Electrical Installation Condition Report

FT/EICR 6522000001896

Client	J&P Thomas	Installation	TMK Upholstery
Address	Meadowview Ind Estate Rose Haven Hamstreet Ashford Kent	Address	Unit 4 Meadowview Ind Estate Hamstreet Ashford Kent
Postcode	TN26 2HH	Postcode	TN26 2NR

Item	Photograph of Observation	Observation Details
6

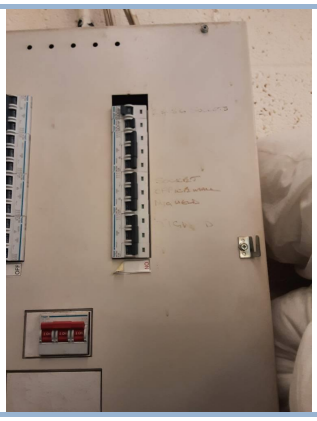
6	8.12.1 For all socket-outlets of rating 32 A or less unless an exception is permitted (411.3.3)-Socket-Outlets: In areas liable to be used by ordinary persons (BA1, BA3) and children (BA2, BA3) - can be used to supply equipment outside - no RCD protection	C2
7	8.12.2 For the supply of mobile equipment not exceeding 32 A rating for use outdoors (411.3.3)-RCD protection provided exceeds 30 mA	C2
8	9.18 Condition of accessories including socket-outlets, switches and joint boxes (651.2 (v))-Socket faces with no isolation switches on them	C2
